2CAN021302

SUBJECT: Response to Request for Additional Information  
Request for Relief ANO2-ISI-010  
Arkansas Nuclear One, Unit 2  
Docket No. 50-368  
License No. NPF-6

**Response to Request for Additional Information  
Relief Request - ANO2-ISI-010**

**Scan Plan and Coverage for ISI Component 02-T-083**

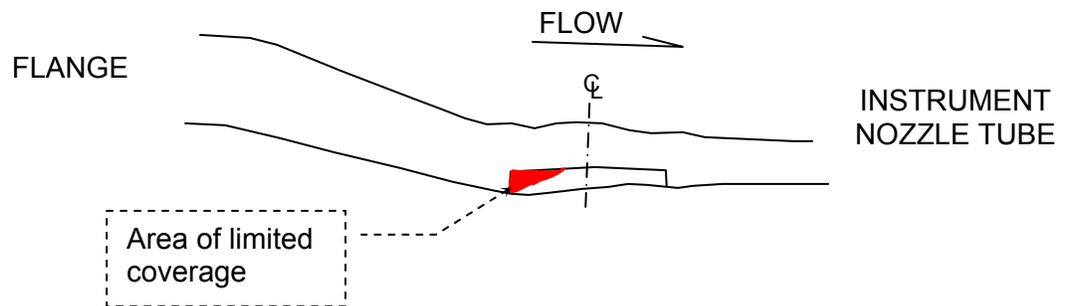
Component Description			Additional Information								
Item Number	Comp. ID	Item Description	Safety Significance (High or Med)	Examined with ASME Sect. XI App VIII procedure	Dia. (in)	Wall Thick. (in)	Material	Reason for missed coverage	Examined RI-ISI (Y/N)	Degradation Mechanism	Adjacent Weld Examined (Y/N)
B9.11	02-T-082	Reactor Vessel Closure Head (RVCH) Instrument Nozzle Tube to Flange #82	None Identified	Y 2008 2R19	5.565	0.563	Stainless Steel (SS) to SB-167 Nickel-Chromium-Iron (Ni-Cr-Fe)	Missed coverage was due to Instrument Nozzle Tube to Flange/Weld Configuration. The inside surface was examined. The upper portion of the code volume was missed. 80% exam. See Figure 1	N	N/A	N/A
B9.11	02-T-083	RVCH Instrument Nozzle Tube to Flange #83	None Identified	Y 2008 2R19	5.565	0.563	SS to SB-167 Ni-Cr-Fe	Missed coverage was due to Instrument Nozzle Tube to Flange/Weld Configuration. The inside surface was examined. The upper portion of the code volume was missed. 80% exam. See Figure 2	N	N/A	N/A

**Scan Plan and Coverage for ISI Component 22-004**

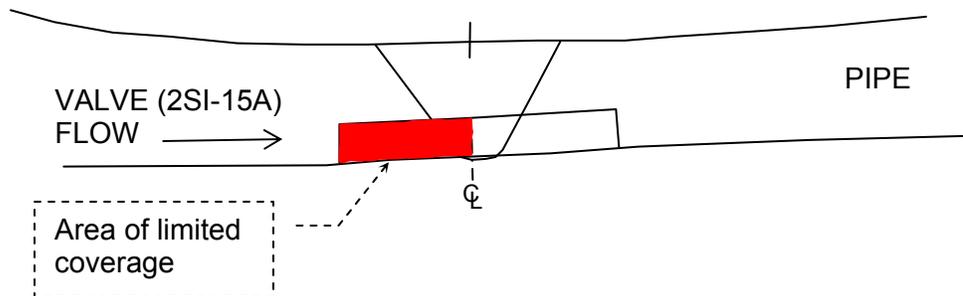
Component Description			Additional Information								
Item Number	Comp. ID	Item Description	Safety Significance (High or Med)	Examined with ASME Sect. XI App VIII procedure	Dia. (in)	Wall Thick. (in)	Material	Reason for missed coverage	Examined RI-ISI (Y/N)	Degradation Mechanism	Adjacent Weld Examined (Y/N)
B9.11	22-001	Safety Injection Loop 1B Safe End to Nozzle Circ Weld – DM Weld	High	N 2000 2R14	12.0	1.125	SA-351 CF-8M CSS to SA-182 CS	Missed coverage was due to the Safe End to Nozzle Weld Configuration. 100% of the volume was scanned; however, most of the nozzle side was only scanned in one direction. 70% exam. See Figure 5	Y	None Identified	N
R1.11	22-004	Safety Injection Loop 1B Valve to Pipe Circ Weld	High	Y 2005 2R17	12.0	1.125	SS SA-376 TP 316	Missed coverage was due to single side exam due to the Valve to Pipe Configuration. Sound was projected into the valve side of the weld. Coverage volume limited to 50% due to procedure qualification restrictions. See Figure 6	Y	None Identified	Y

**Scan Plan and Coverage for ISI Component 23-001**

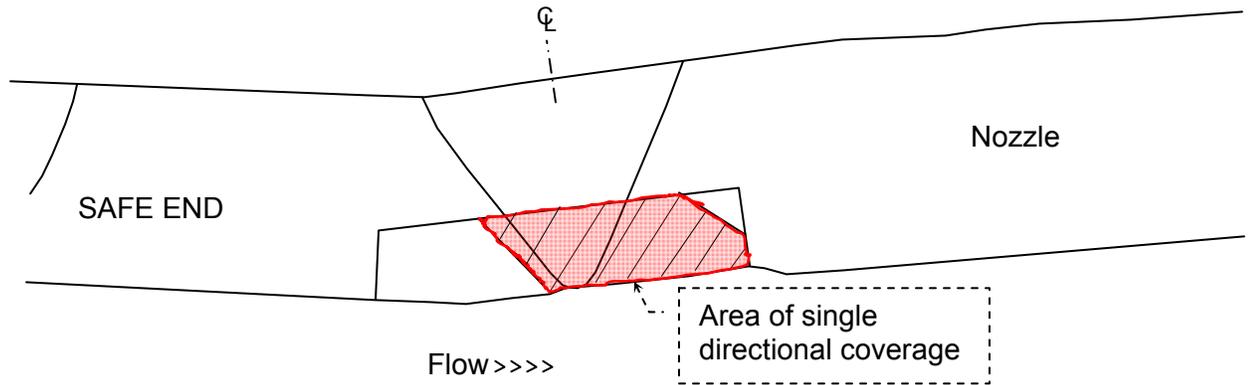
R1.11	22-005	Safety Injection Loop 1B Pipe to Valve Circ Weld	Med	Y 2005 2R17	12.0	1.125	SS SA-376 TP 316	Missed coverage was due to Single Side exam due to the Pipe to Valve Configuration. Sound was projected into the valve side of the weld. Coverage volume limited to 50% due to procedure qualification restrictions. See Figure 7	Y	IGSCC TASCS	Y
B9.11	23-001	Safety Injection Loop 2A Safe End to Nozzle Circ Weld – DM Weld	High	N 2000 2R14	12.0	1.125	SA-351 CF-8M CSS to SA-182 CS	Missed Coverage was due to the Safe End to Nozzle Weld Configuration. 100% of the volume was scanned; however, the nozzle side was only scanned in one direction. 70% exam. See Figure 8	Y	None Identified	N

**Figure 10**  
**Scan Plan and Coverage for ISI Component 23-007**  
Not to Scale

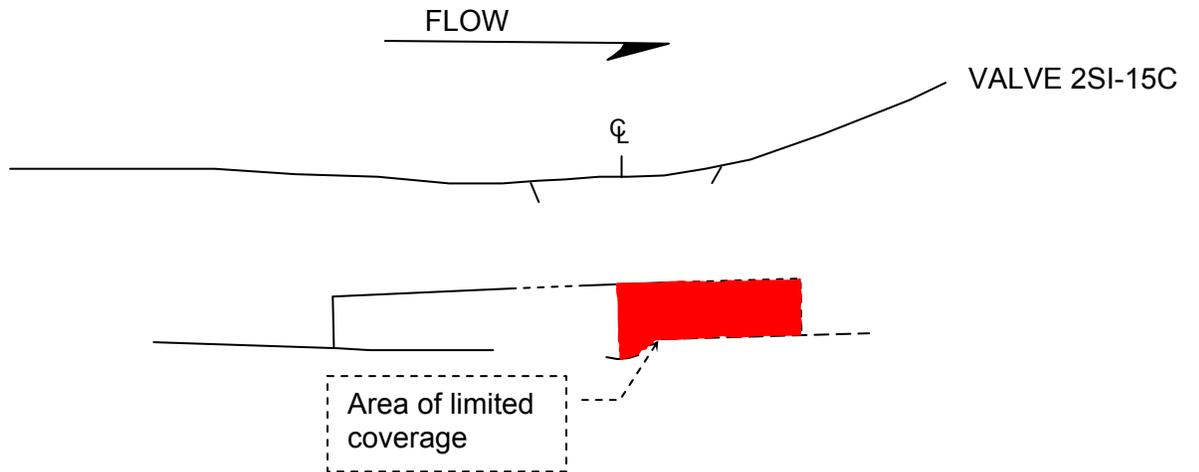
Component Description			Additional Information								
Item Number	Comp. ID	Item Description	Safety Significance (High or Med)	Examined with ASME Sect. XI App VIII procedure	Dia. (in)	Wall Thick. (in)	Material	Reason for missed coverage	Examined RI-ISI (Y/N)	Degradation Mechanism	Adjacent Weld Examined (Y/N)
B9.11	23-006	Safety Injection Loop 2A Valve to Pipe Circ Weld	High	Y 2002 2R15	12.0	1.125	SS SA-376 TP 316	Missed coverage was due to Single Side exam due to the Valve to Pipe Configuration. Sound was projected into the valve side of the weld. Coverage volume limited to 50% due to procedure qualification restrictions. See Figure 9	Y	None Identified	Y
B9.11	23-007	Safety Injection Loop 2A Pipe to Valve Circ Weld	Med	Y 2002 2R15	12.0	1.125	SS SA-376 TP 316	Missed coverage was due to Single Side exam due to the Pipe to Valve Configuration. Sound was projected into the valve side of the weld. Coverage volume limited to 50% due to procedure qualification restrictions. See Figure 10	Y	IGSCC TASCS	Y

**Figure 12**  
**Scan Plan and Coverage for ISI Component 24-006**

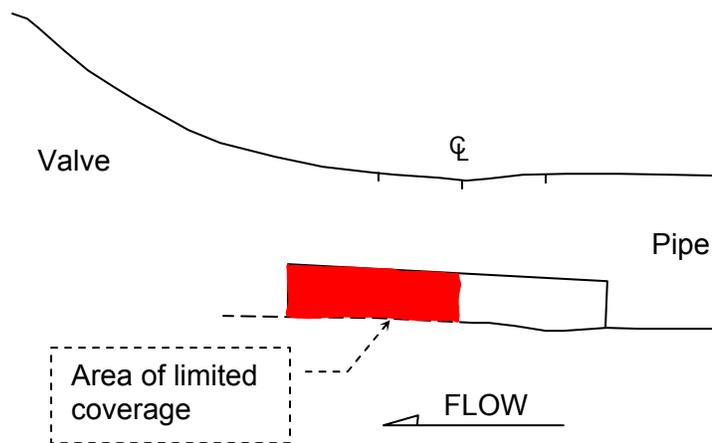
B9.11	24-001	Safety Injection Loop 2B Safe End to Nozzle Circ Weld – DM Weld	High	N 2000 2R14	12.0	1.125	SA-351 CF- 8M CSS to SA-182 CS	Missed coverage was due to the Safe End to Nozzle Weld Configuration. 100% of the volume was scanned; however, the nozzle side was only scanned in one direction. 66.5% exam. See Figure 11	Y	None Identified	N
R1.11	24-006	Safety Injection Loop 2B Pipe to Valve Circ Weld	Med	Y 2006 2R18	12.0	1.125	SS SA-376 TP 316	Missed coverage was due to Single Side exam due to the Pipe to Valve Configuration. Sound was projected into the valve side of the weld. Coverage volume limited to 50% due to procedure qualification restrictions. See Figure 12	Y	IGSCC TASCS	N

**Figure 14**

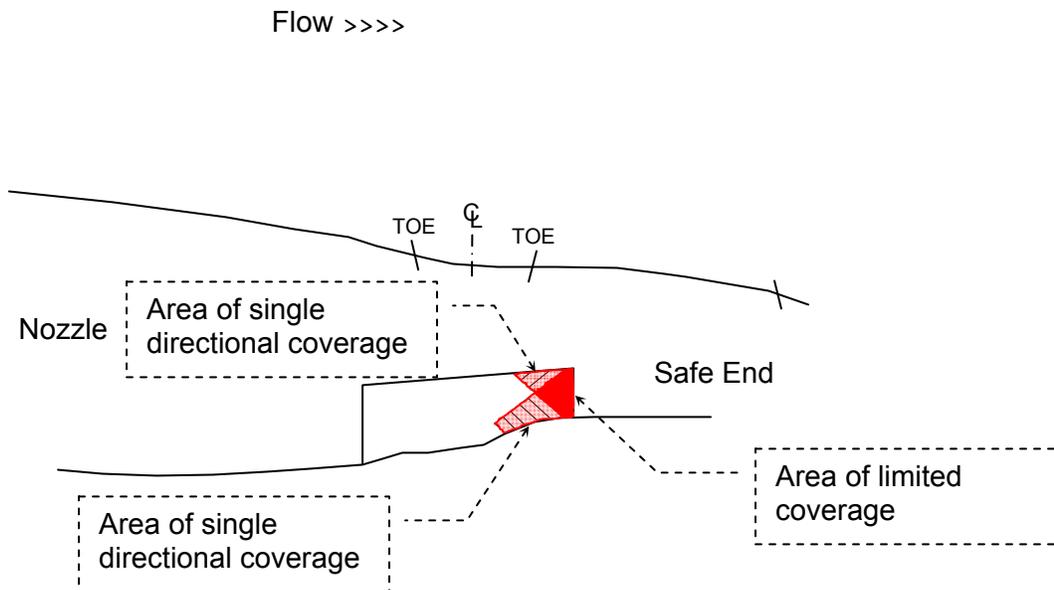
Component Description			Additional Information								
Item Number	Comp. ID	Item Description	Safety Significance (High or Med)	Examined with ASME Sect. XI App VIII procedure	Dia. (in)	Wall Thick. (in)	Material	Reason for missed coverage	Examined RI-ISI (Y/N)	Degradation Mechanism	Adjacent Weld Examined (Y/N)
B9.11	25-024	Shutdown Cooling Pipe to Weld-o-let Circ Weld	High	Y 2002 2R15	3.0	0.438	SA-312 TP 316 SS to SA-182 F316 SS	Missed coverage was due to Single Side exam due to the Pipe to Weld-o-let Configuration where coverage was limited in the upper code volume. 68.75% exam. See Figure 13	Y	TASCS	Y
B9.21	27-001	Pressurizer Spray Loop 1B Safe End to Nozzle Circ Weld – DM Weld	Med	N 2R14 2002	3.0	0.438	SA-182 TP 316 SS to SA-105 CS	Missed coverage was due to the Nozzle to Safe End Weld and adjacent Pipe Weld Configuration. The area of limited coverage is in the base material on the Safe End side. 83% exam. See Figure 14	Y	None Identified	Y

**Figure 15**

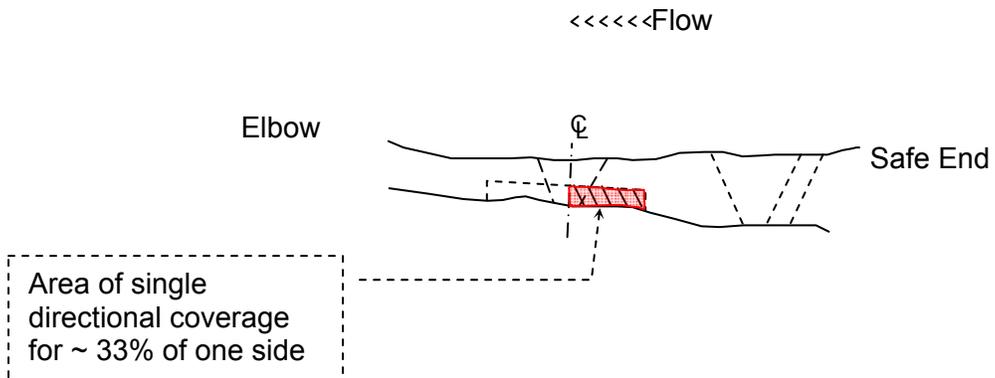
R1.20	27-002	Pressurizer Spray Piping Loop 1B Elbow to Safe End Circ Weld	Med	Y 2006 2R18	3.0	0.438	SA-403 WP316 SS to SA-182 TP 316	Missed coverage was due to the intrados of the elbow configuration for approximately 33% of scan on one side. Volume was scanned 100% in one direction. 83% exam. See Figure 15	Y	None Identified	Y
R1.20	27-003	Pressurizer Spray Piping Loop 1B Elbow to Pipe Circ Weld	Med	Y 2006 2R18	3.0	0.438	SS SA-312 TP 316	Missed coverage was due to the intrados of the elbow configuration for approximately 33% of scan on one side. Volume was scanned 100% in one direction. 83% exam. See Figure 16	Y	None Identified	Y

**Figure 18**

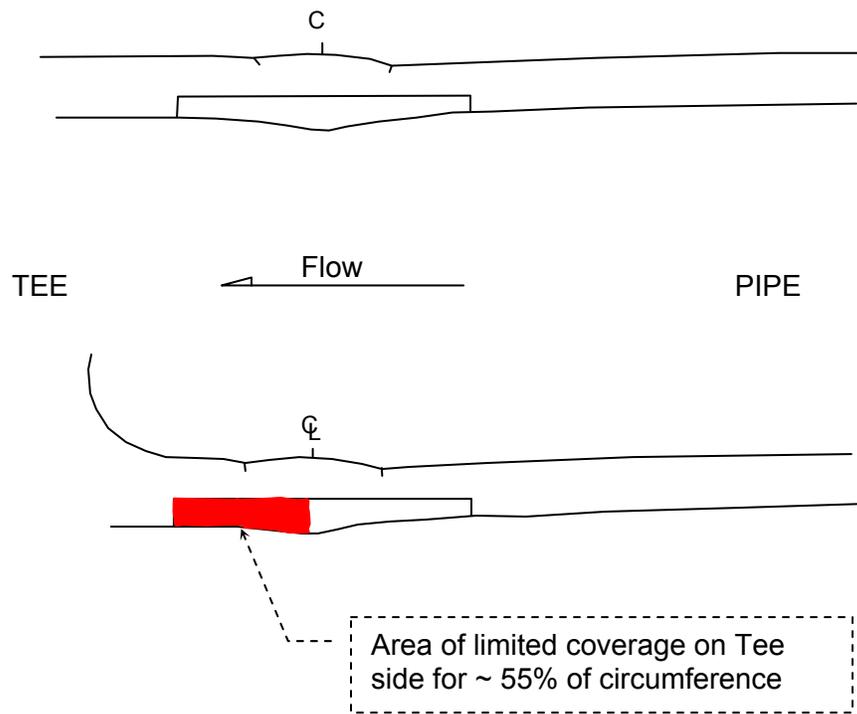
Component Description			Additional Information								
Item Number	Comp. ID	Item Description	Safety Significance (High or Med)	Examined with ASME Sect. XI App VIII procedure	Dia. (in)	Wall Thick. (in)	Material	Reason for missed coverage	Examined RI-ISI (Y/N)	Degradation Mechanism	Adjacent Weld Examined (Y/N)
R1.20	27-065	Pressurizer Spray Piping Loop 1B Valve to Pipe Circ Weld	Med	Y 2005 2R17	3.0	0.438	SS SA-312 TP 316	Missed coverage was due to Single Side exam due to the Valve to Pipe Configuration. Sound was projected into the valve side of the weld. Coverage volume limited to 50% due to procedure qualification restrictions. See Figure 17	Y	None Identified	Y
R1.20	27-066	Pressurizer Spray Piping Loop 1B Pipe to Tee Circ Weld	Med	Y 2005 2R17	3.0	0.438	SS SA-312 TP 316	Missed coverage was due to the tee configuration for approximately 55% of scan on one side. 73% exam. See Figure 18	Y	None Identified	Y

**Figure 19**  
**Scan Plan and Coverage for ISI Component 40-005**

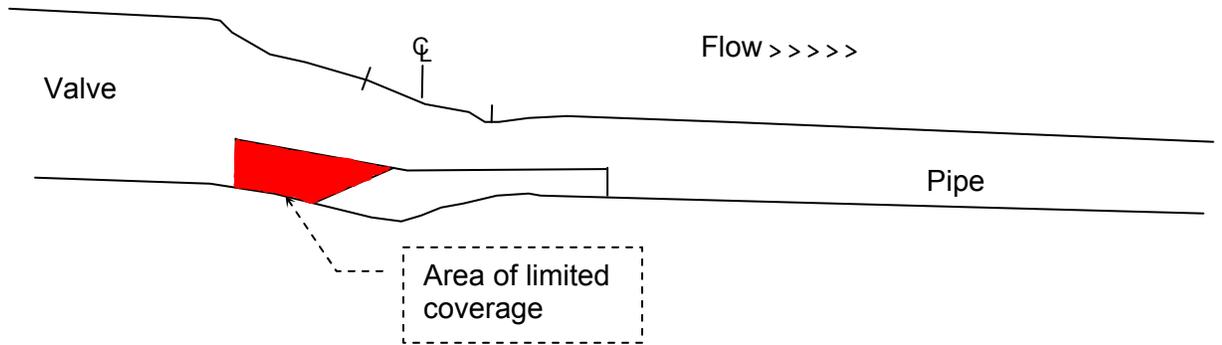
B9.21	40-005	Charging Piping Loop 1A Valve to Pipe Circ Weld	Med	Y 2002 2R15	2.0	0.344	SS SA-312 TP 316	Missed coverage was due to Single Side exam due to the Valve to Pipe Configuration. Volume was limited on the valve side. 59.6% exam. See Figure 19	Y	None Identified	N
B9.21	40-008	Charging Piping Loop 1A Pipe to Elbow Circ Weld	Med	Y 2002 2R15	2.0	0.344	SS SA-312 TP 316 to SA- 403 WP 316	Missed coverage was due to the intrados of the elbow configuration for approximately 20% on one side and weld crown. 74% exam. See Figure 20	Y	None Identified	Y
R1.11	40-025	Charging Piping Loop 1A Elbow to Safe End Circ Weld	High	Y 2009 2R20	2.0	0.344	SS/SS SA-403 TP 316 to SA- 182 TP 316	Missed coverage was due to the intrados of the elbow configuration for approximately 30% on one side. 85% exam. See Figure 21	Y	Thermal Transient (TT)	N

**Figure 24**

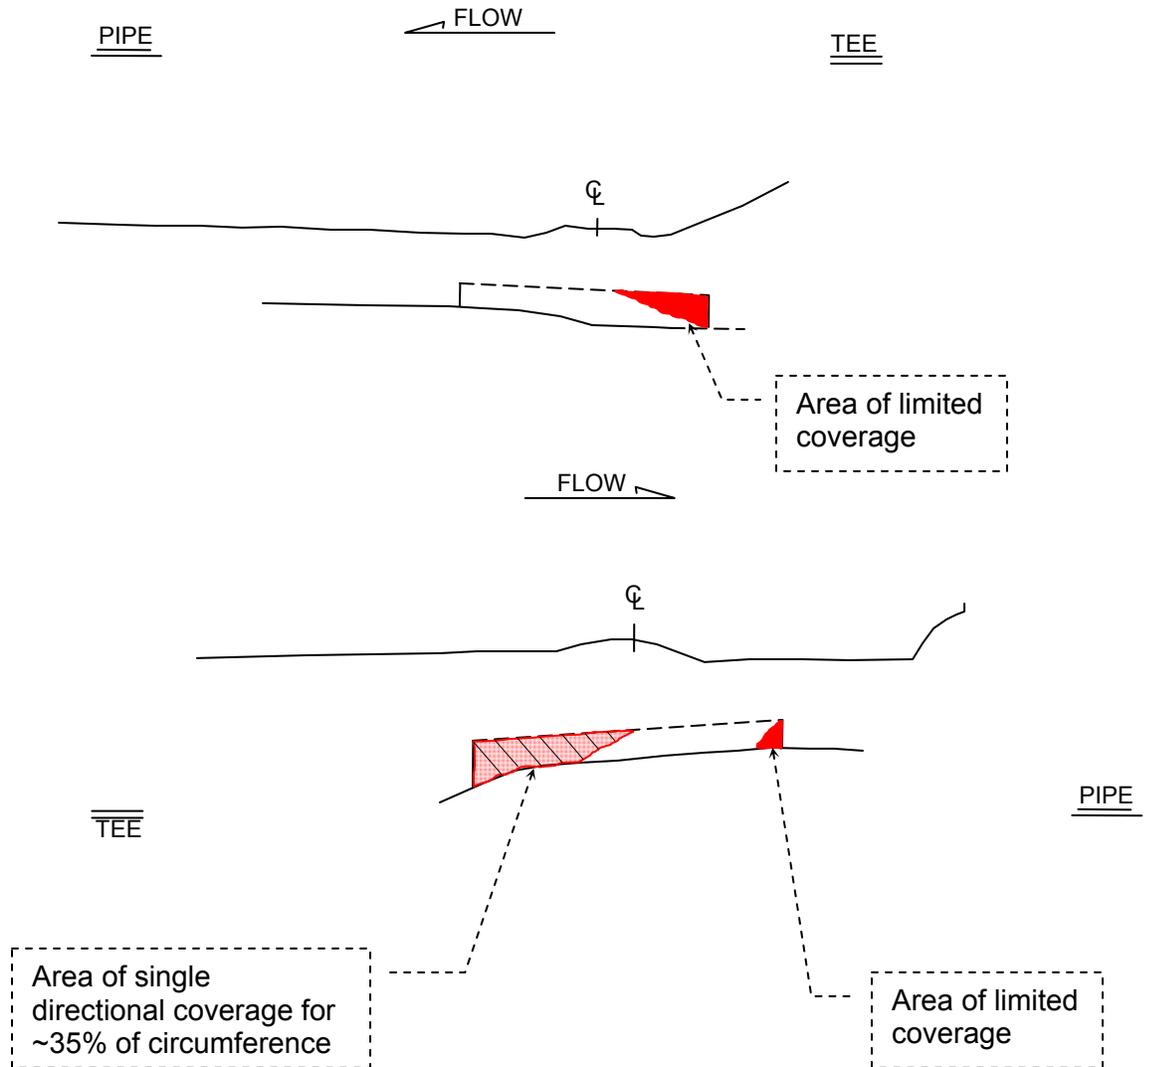
Component Description			Additional Information								
Item Number	Comp. ID	Item Description	Safety Significance (High or Med)	Examined with ASME Sect. XI App VIII procedure	Dia. (in)	Wall Thick. (in)	Material	Reason for missed coverage	Examined RI-ISI (Y/N)	Degradation Mechanism	Adjacent Weld Examined (Y/N)
B9.21	41-003	Charging Piping Loop 2A Valve to Pipe Circ Weld	Med	Y 2002 2R15	2.0	0.344	SS SA-312 TP 316	Missed coverage was due to Single Side exam due to the Valve to Pipe Configuration. Volume was limited on the valve side. 60% exam. See Figure 22	Y	None Identified	N
B9.21	41-003C	Charging Piping Loop 2A Tee to Pipe Circ Weld	Med	Y 2002 2R15	2.0	0.344	SS SA-312 TP 316	Missed coverage was due to Single Side exam due to the Tee to Pipe configuration. Volume was limited on the Tee side. 60% exam. See Figure 23	Y	None Identified	N
B9.11	43-022	Pressurizer LTOP Tee to Pipe Circ Weld	High	Y 2003 2R16	6.0	0.562	SS SA-312 TP 316	Missed coverage was due to the Tee to Pipe configuration and branch connection. Volume was limited in base material. 71.2% exam. See Figure 24	Y	TASCS	Y

**Figure 25**  
**Scan Plan and Coverage for ISI Component 43-023**  
Not to Scale

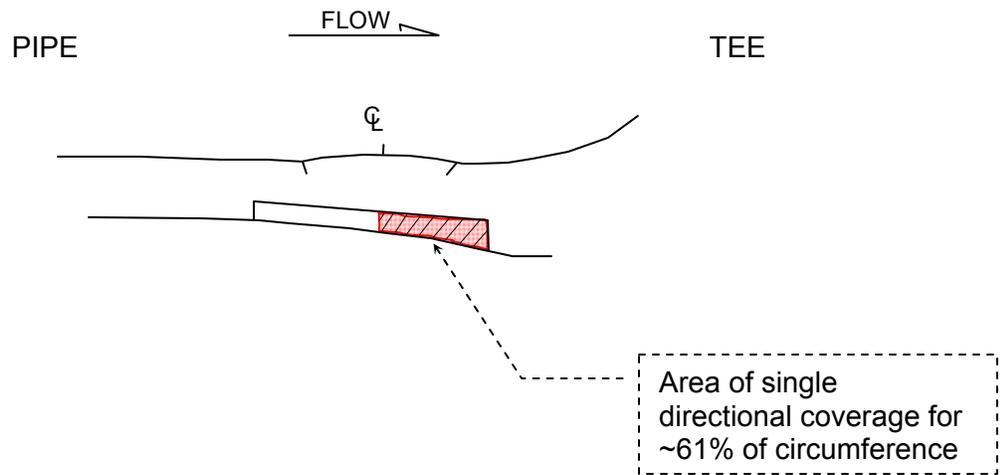
R1.11	43-023	Pressurizer LTOP Tee to Pipe Circ Weld	High	Y 2005 2R17	6.0	0.562	SS SA-312 TP 316	Missed coverage was due to the Tee to Pipe configuration. Sound was projected into Tee side but scan credit restricted by procedure as single side. 81% exam. See Figure 25	Y	TASCS	Y
B9.11	43-027	Pressurizer LTOP Pipe to Valve Circ Weld	Med	Y 2002 2R15	4.0	0.438	SS SA-312 TP 316	Missed coverage was due to Single Side exam due to the Valve to Pipe Configuration. Volume was limited on the valve side. 67.6% exam. See Figure 26	Y	TASCS TT	N

**Figure 29**  
**Scan Plan and Coverage for ISI Component 15-008**

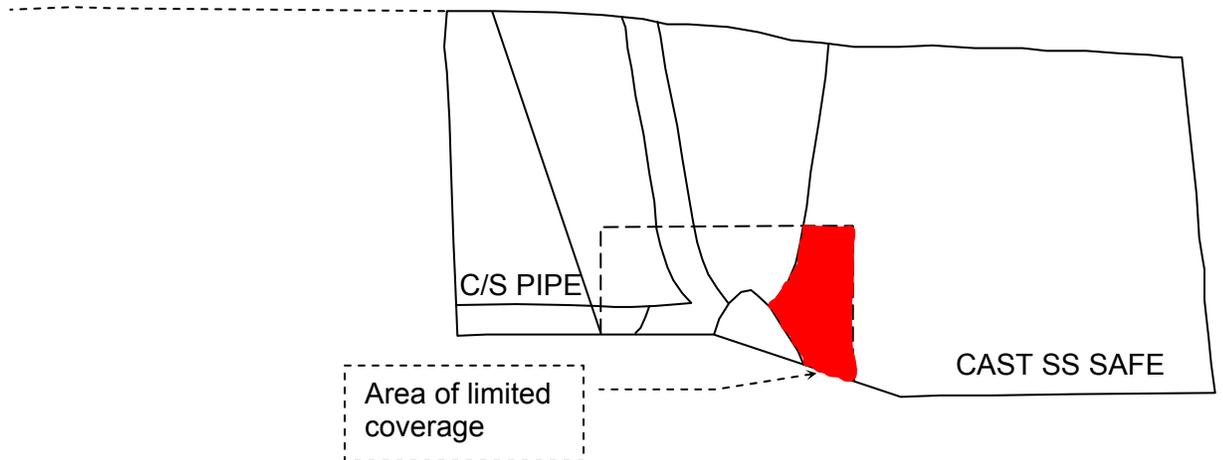
Component Description			Additional Information								
Item Number	Comp. ID	Item Description	Safety Significance (High or Med)	Examined with ASME Sect. XI App VIII procedure	Dia. (in)	Wall Thick. (in)	Material	Reason for missed coverage	Examined RI-ISI (Y/N)	Degradation Mechanism	Adjacent Weld Examined (Y/N)
B9.11	43-033	Pressurizer LTOP Tee to Pipe Circ Weld	Med	Y 2002 2R15	3.0	0.438	SS SA-312 TP 316	Missed coverage was due to the Tee to Pipe configuration. Volume was limited on Tee side. 72.5% exam. See Figure 27	Y	TASCS TT	N
R1.20	13-008	RCP 2P-32C Discharge Nozzle SE to Pipe Circ Weld -DM Weld	Med	Y 2009 2R20	30.0	3.25	CSS/SS to SA-533- 67A	Missed Coverage was due to Cast Stainless Steel Safe End Side and Weld Crown. Procedure is restricted from crediting Centrifugal Cast Stainless Steel (CCSS) volume credit. Scanned with Phased Array. 60.1% exam. See Figure 28	Y	None Identified	N
R1.20	15-008	RCP 2P-32D Discharge Nozzle SE to Pipe Circ Weld-DM Weld	Med	Y 2009 2R10	30.0	3.25	CSS/SS to SA-533- 67A	Missed Coverage was due to Cast Stainless Steel Safe End Side and Weld Crown. Procedure restricted from crediting CCSS volume credit. Scanned with Phased Array. 62.8% exam. See Figure 29	Y	None Identified	N
